Report Type: DA Access Report
Reference Number: 18114
Client: Designcorp Architects
Site Address: 1 Edna Street, Kingwood

ACCESS REPORT

This Access Compliance Report is to accompany a Development Application for the development proposed at 1 Edna Street, Kingwood

This development proposes a New Building with a total of 16 Residential units in a Boarding house development. The development is within Penrith City Council LGA.

Floor plans shown above

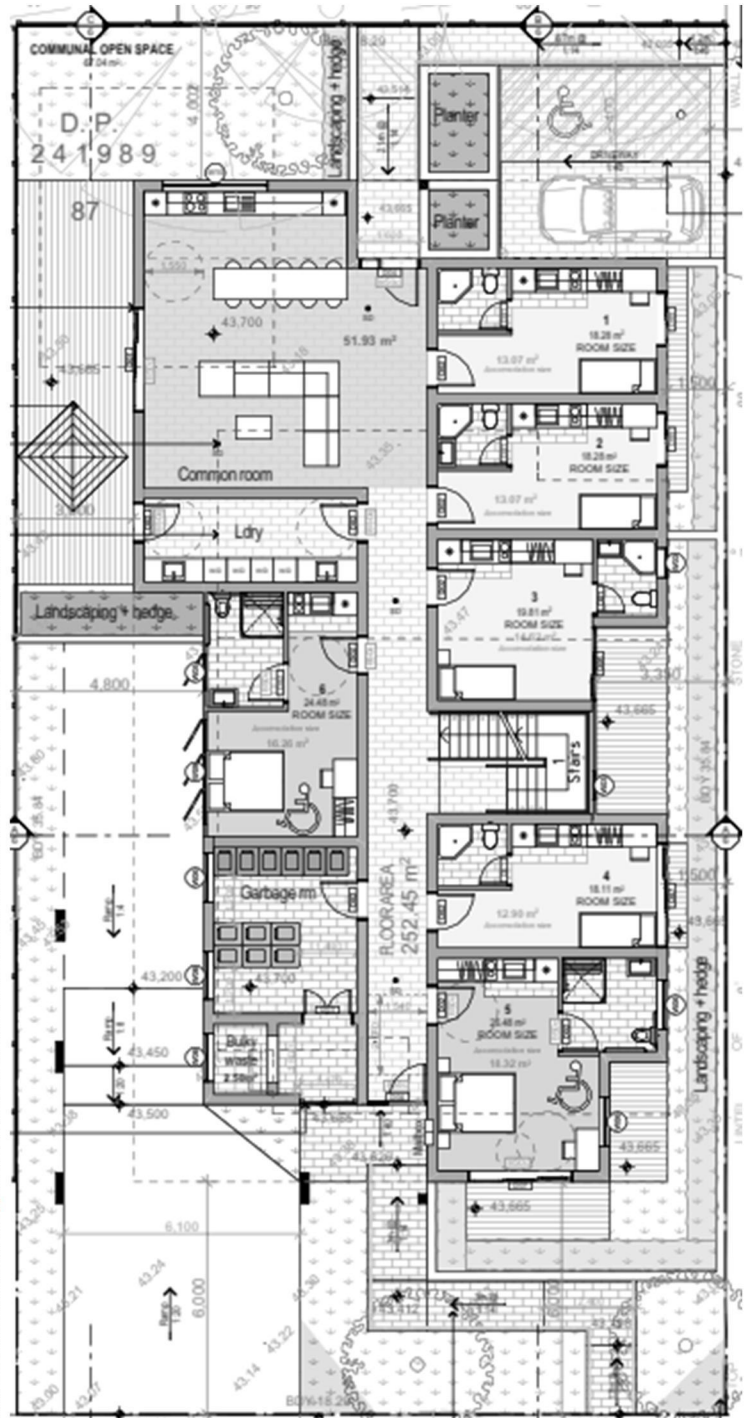
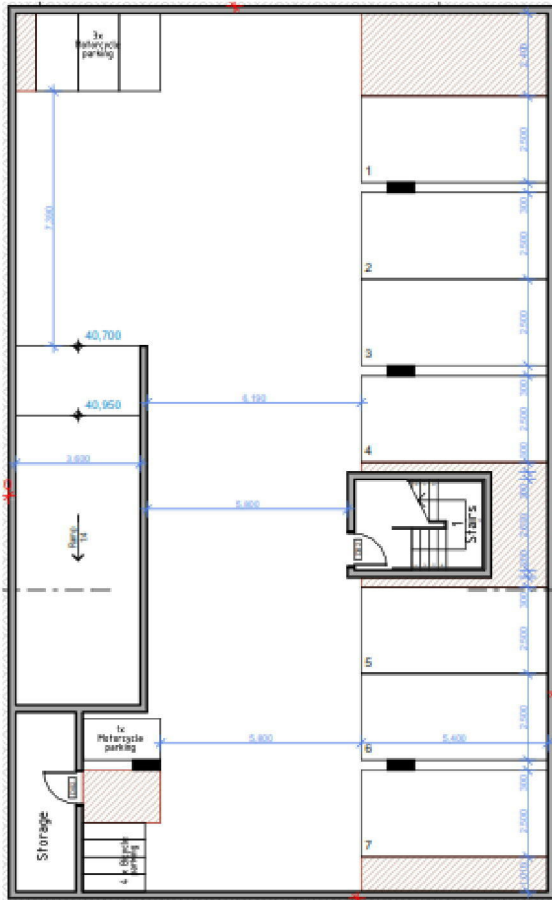
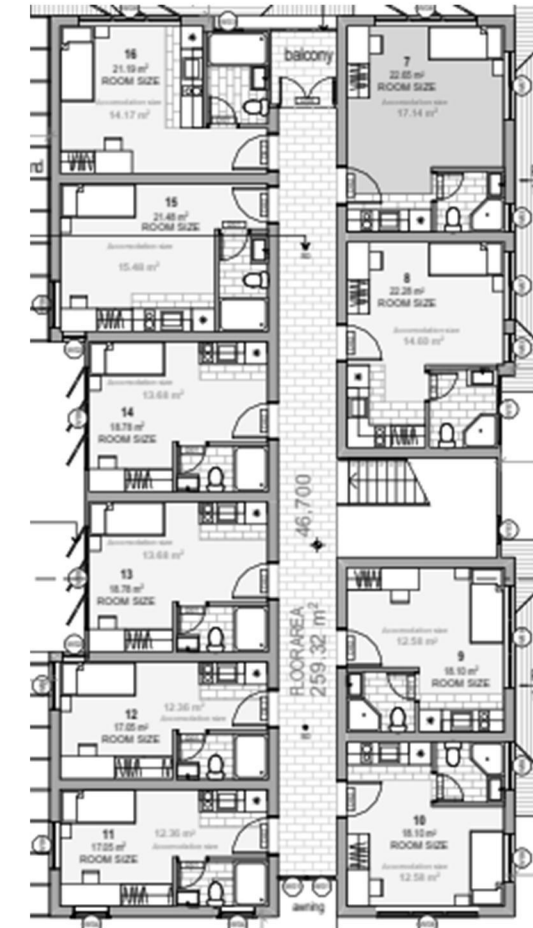
The assessment of the proposed development has been undertaken to the extent necessary to issue DA (Development application) consent under the Environmental Planning and Assessment Act. The proposal achieves the spatial requirements to provide access for people with a disability and it is assumed that assessment of the detailed requirements such as assessment of internal fit-out, details of stairs, ramps and other features will occur at CC (Construction Certificate) stage.

By compliance with the recommendation in this report, the development complies with the requirements of Access Code of Disability (Access to Premises-Building) Standards 2010 and the Disability Access relevant sections of Building Code of Australia 2016.

Access from site boundary is shown above

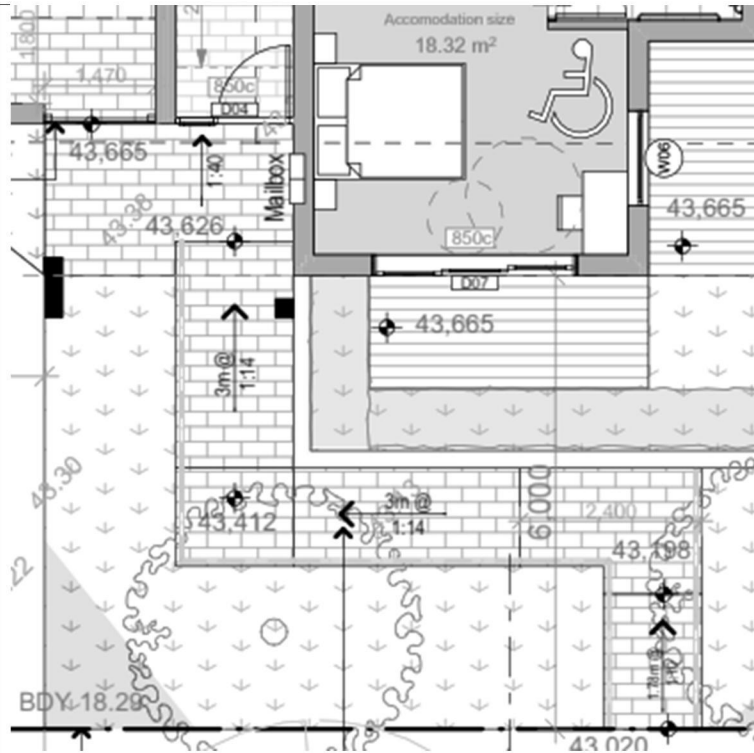
Requirement	External Walkway / Pedestrian Access- to be as per requirements of AS1428-2009.
Compliance Comments	Capable of compliance. Details to be verified at CC stage of works.
Requirement	Accessway is required through: <ul style="list-style-type: none"> - Main entry; and - Not less than 50% of all pedestrian entrances; and - In building with floor area over 500m², non-accessible entry and accessible entry to be not more than 50M apart.
Compliance Comments	Complies The building has only 1 pedestrian entry, which has been designed to be accessible. Details to be verified at CC stage of works.

Access from Car parking space is shown above

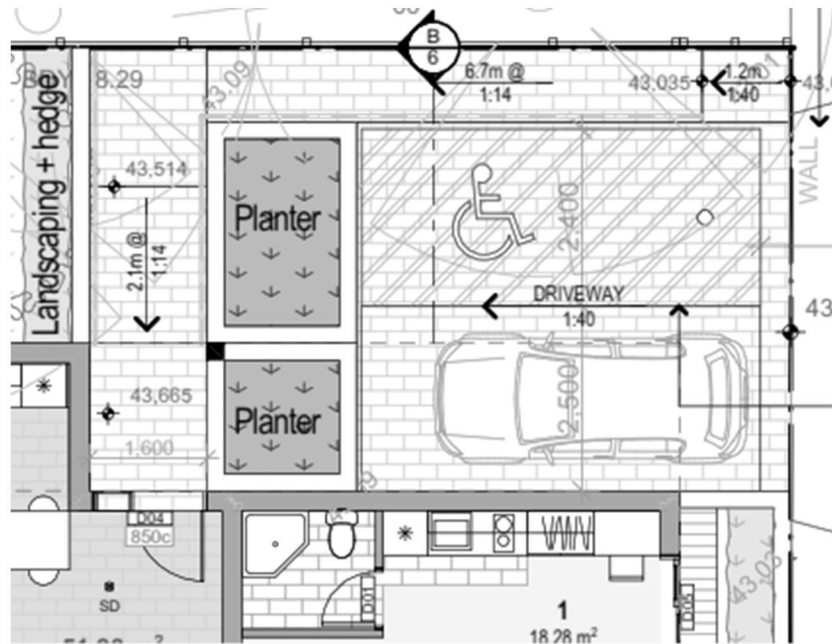
Total number of SOUs	Accessible SOUs required	1 to 10 SOUs	1 accessible SOU	11 to 40 SOUs	2 accessible SOUs	41 to 60 SOUs	3 accessible SOUs	61 to 80 SOUs	4 accessible SOUs	81 to 100 SOUs	5 accessible SOUs	101 to 200 SOUs	5 accessible SOUs + 1 per 25 (in excess of 100)	201 to 500 SOUs	9 accessible SOUs + 1 per 30 (in excess of 200)	More than 500 SOUs	19 accessible SOUs + 1 per 50 (in excess of 500)
Total number of SOUs	Accessible SOUs required																		
1 to 10 SOUs	1 accessible SOU																		
11 to 40 SOUs	2 accessible SOUs																		
41 to 60 SOUs	3 accessible SOUs																		
61 to 80 SOUs	4 accessible SOUs																		
81 to 100 SOUs	5 accessible SOUs																		
101 to 200 SOUs	5 accessible SOUs + 1 per 25 (in excess of 100)																		
201 to 500 SOUs	9 accessible SOUs + 1 per 30 (in excess of 200)																		
More than 500 SOUs	19 accessible SOUs + 1 per 50 (in excess of 500)																		
Compliance Comments	<p>Complies.</p> <ul style="list-style-type: none"> - The development has a total of 16 SOUs and therefore 2 accessible SOUs have been provided, representing the range of available rooms with no more than 2 Accessible SOUs adjacent to each other. - Accessible SOU numbers are unit 5 and unit 6. - SOU 5 has been provided with LH transfer toilet and SOU 6 has been provided with RH transfer toilet to satisfy the requirement of range of available rooms. - Access has been provided from the main pedestrian entry doorway to the entry doors of all SOUs on at least 1 level (ground floor) by means of accessible pathways and lifts. Therefore, lift access is not required to the upper floor level as per the BCA. - Access has been provided to at least 1 of each common use spaces such as communal room, communal laundry and communal garden on Ground floor level. - Access has been provided to common use garbage storage room on the ground floor level and has been designed to be accessible from the communal area. <p>Details to be verified at CC stage of works.</p>																		
	BCA Part D3.2 Access to buildings																		
Requirement	<p>Accessway is required from;</p> <ul style="list-style-type: none"> - Main pedestrian entry at the site boundary for new buildings. - Any other accessible building connected by a pedestrian link. - Accessible car parking spaces. 																		
Compliance Comments	<p>Complies.</p> <ul style="list-style-type: none"> - Access by means of 1:14 grade ramps and 1:10 grade step ramps has been provided from the main pedestrian entry at the site boundary. - Level access has been provided from accessible car parking space. <p>Details to be verified at CC stage of works.</p>

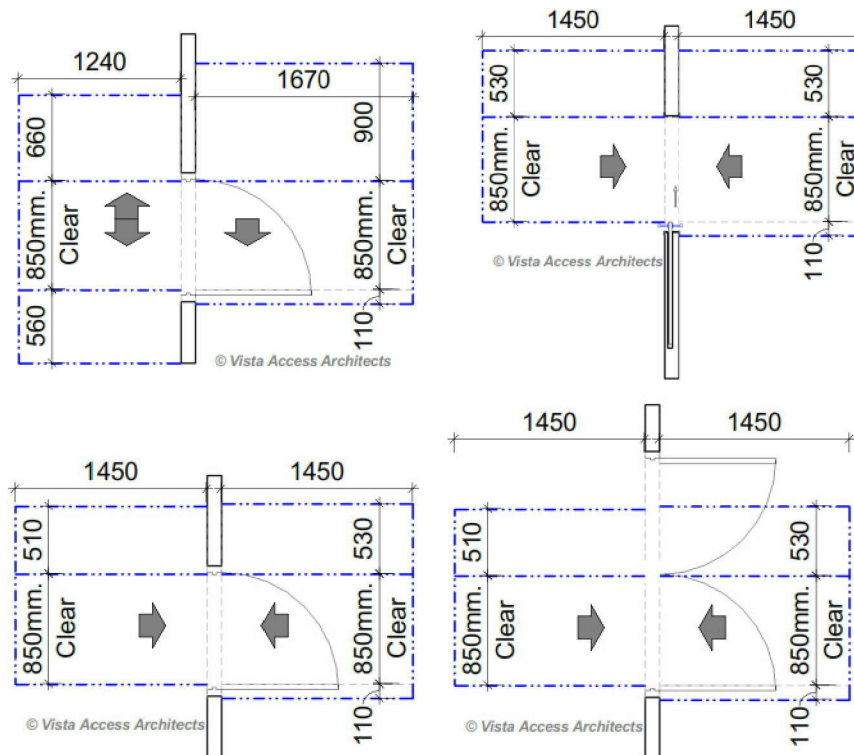
Note that the sliding door that is provided to the communal room will require to have recessed floor tracks and also provide for 530mm latch side space as shown in the diagram above.

This is achievable and the door selections are to be verified at CC stage of works.

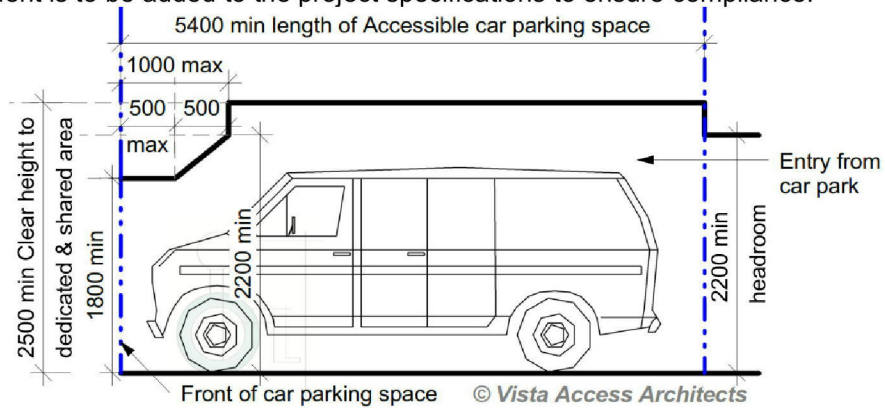
Head heights for both dedicated accessible parking space and the shared zone to be as shown above. No beams, pipes, sprinklers or any other encroachments are permissible for the entire 5.4M width of the dedicated and shared zone as per Section shown above.

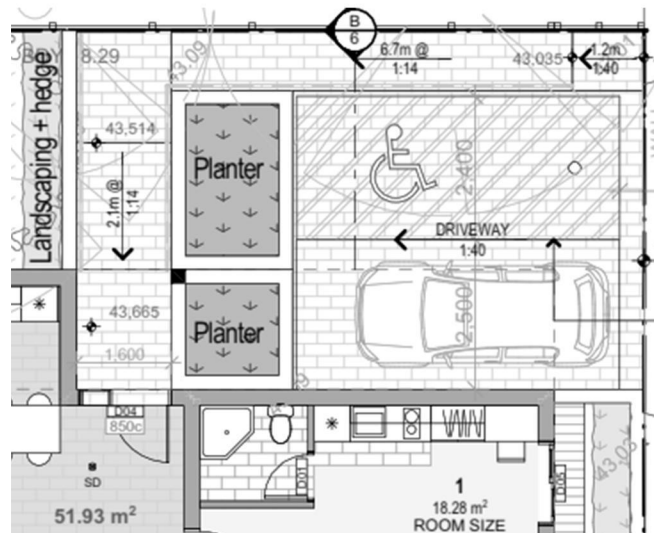
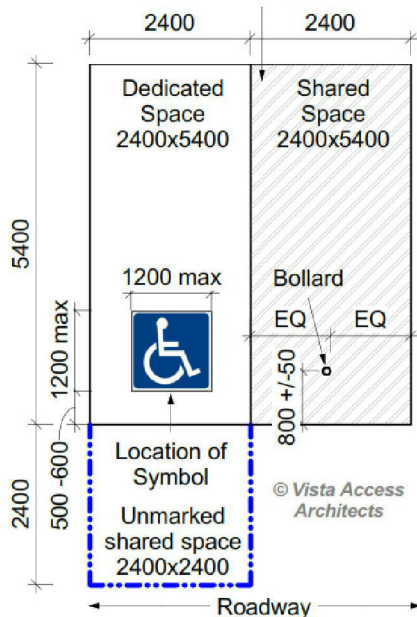
The Accessible parking, shared zones, bollard and linemarking to be as shown above.

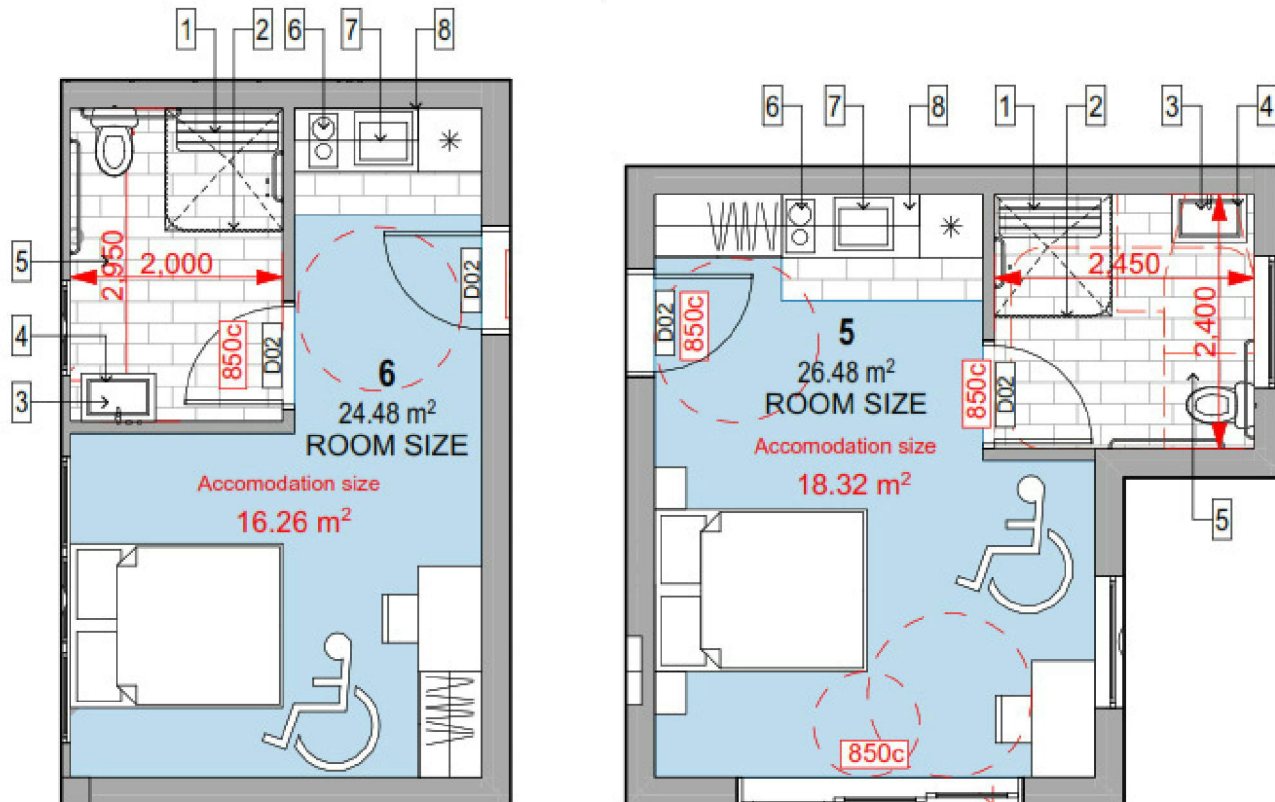
The development has a requirement for 2 Accessible SOUs.
The nominated Accessible SOUs are Unit numbers, 5 and 6 as shown below
